RESPONSE TO REQUEST FOR INFORMATION - SSD-10285 MOD 2

We are writing on behalf of Australian Turf Club (**the applicant**) to address the issues raised in your request for information (**RFI**), dated 23 June 2021 relating to SSD-10285-MOD 2 at Royal Randwick Racecourse. In response to the additional information requested, further information and clarification has been provided in regard to the issues raised to support your assessment of the State significant development application.

Figure 1 Additional detail for QE II Stand link bridge

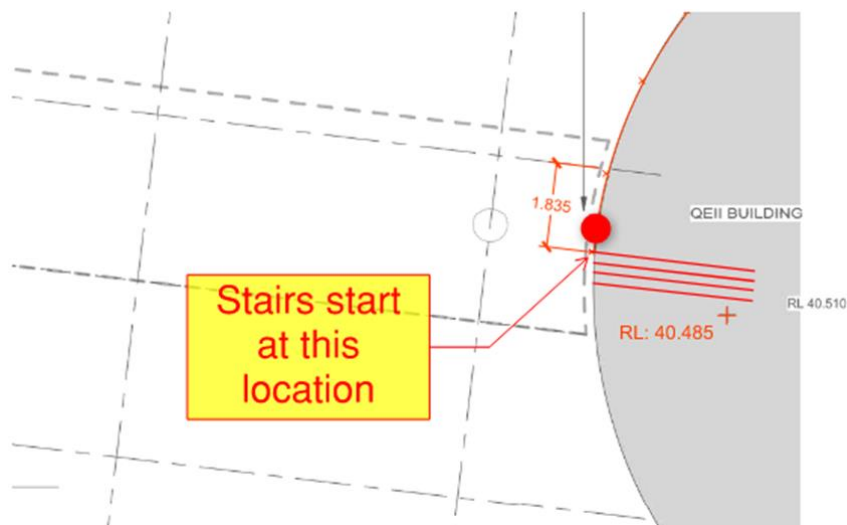
Clarification regarding QE II Stand link bridge

"The alignment of the link bridge was amended for the following reasons:

- *Site survey of the existing QEII drum was undertaken by Taylor;*
- *On-site mapping of the previously proposed link bridge alignment revealed it would clash with the existing stairs, balustrades & structural column – refer below screenshots. (Picture 1)*
- *The angle of the bridge was adjusted to hit the drum further west past the column, and only require modification of the mesh cladding. (Picture 2)*

- *The existing stairs in the QEII drum can't be amended without triggering egress non-compliances for the QEII stand."*
